Range Measurement Procedure for PEV

Different test/estimation methods: Present situation

2 Each Phase Result calculation : Method – Example of Low phase cycle

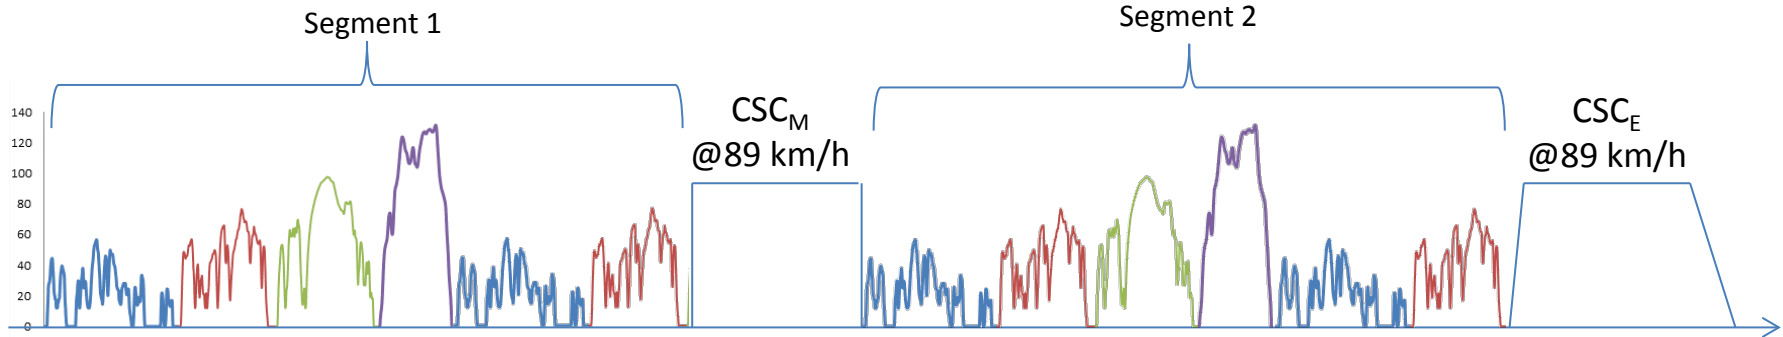
- It will be difficult to measure the voltage (safety issues)
 - ⇒ Is it possible to use the on-board data for 'current' & 'voltage' information ?
- This method is needing some validation (by real test or simulation)
 - ⇒ The validation data - provided by Japan - seem incomplete
 - because the validation result ACEA received from Japan compares the single cycle test (SCT) and the multi cycle test (MCT).
 - Additionally the comparison to consecutive WLTCs is necessary!
- We have to think about the low voltage measurement requirement.
